Subject: RATTLE NOISE FROM FRONT DOOR GLASS	Bulletin No: 09-011/13
	Last Issued: 04/17/2013

2013-2014 CX-5 vehicles with VINs lower than JM3KE*****300112 (produced before November 28, 2012)

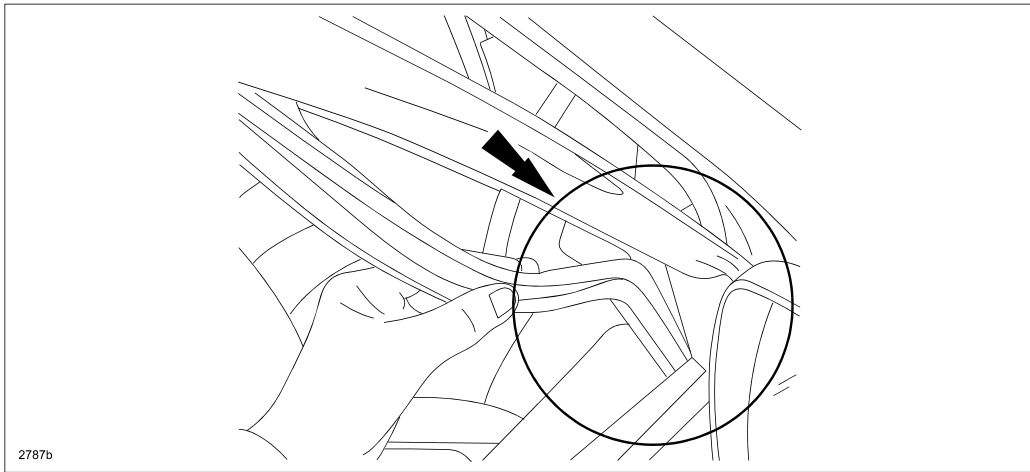
The rattle noise may be caused by insufficient glass run channel holding force. To eliminate this concern, the shape of glass run channel has been changed in order to increase the holding force.

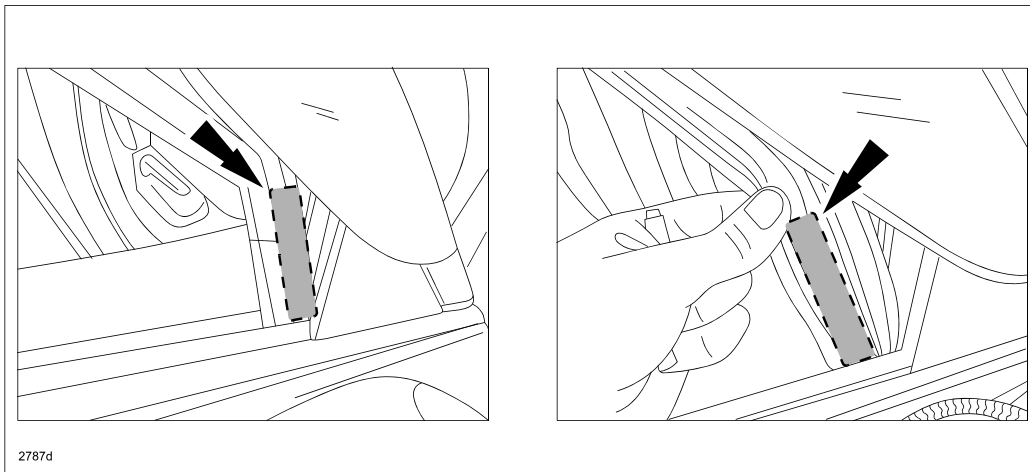
2. Open the door glass fully (right side glass run channel shown below).
3. Pull the glass run channel off of the door frame.

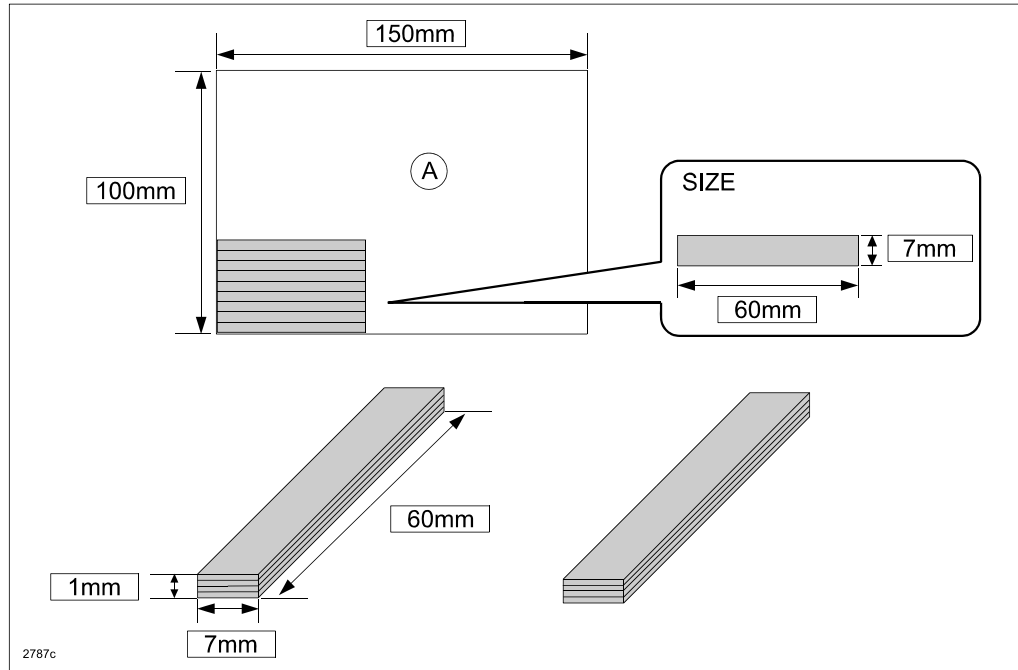
6. Obtain the 0.25mm thick pad (A) from the Noise Parts Set.
7. Using a straight-edge and sharp knife, cut the pad into eight (8) equal pieces:
Pad size: 0.25mm x 7mm x 60mm
8. Stack four (4) pads on top of one another to create a 1mm thick pad.

NOTE: Final pad dimensions: 1mm thick x 7mm wide x 60mm long.

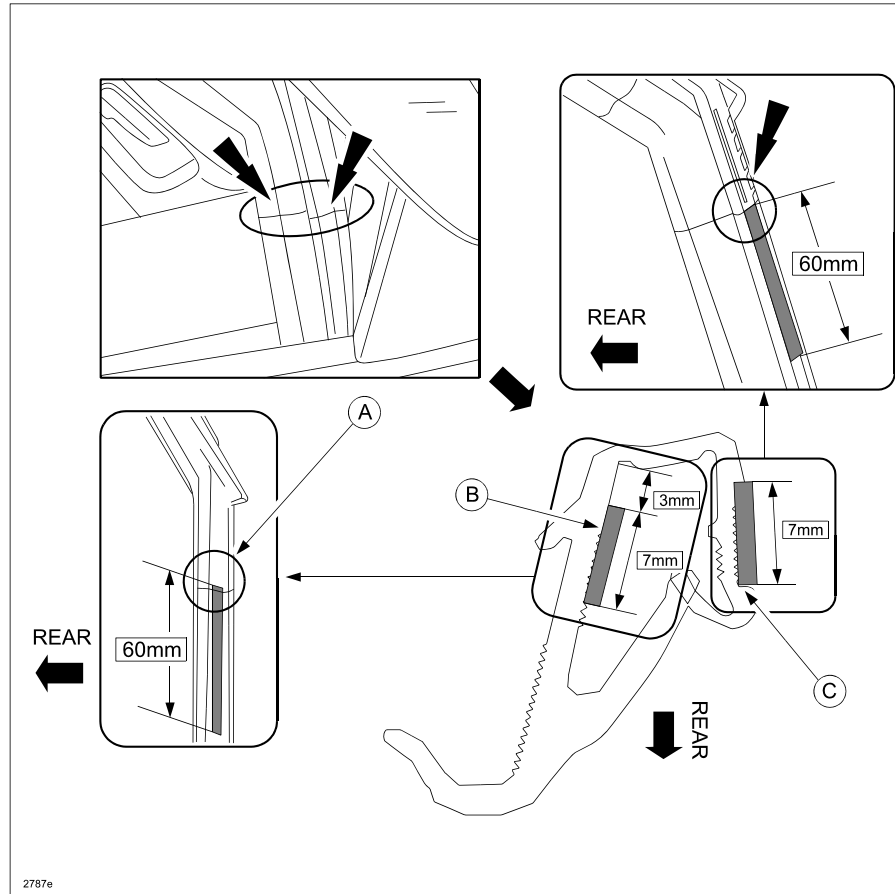
10. Following steps a-c, attach both pads onto the glass run channel positioned below the molded joint line.
- Align the upper edge of the first pad with the molded joint line (A).
 - Position the first pad 3mm away from the back of the glass run channel (B).
 - Attach the second pad by aligning it with the bottom of the outer line (C).
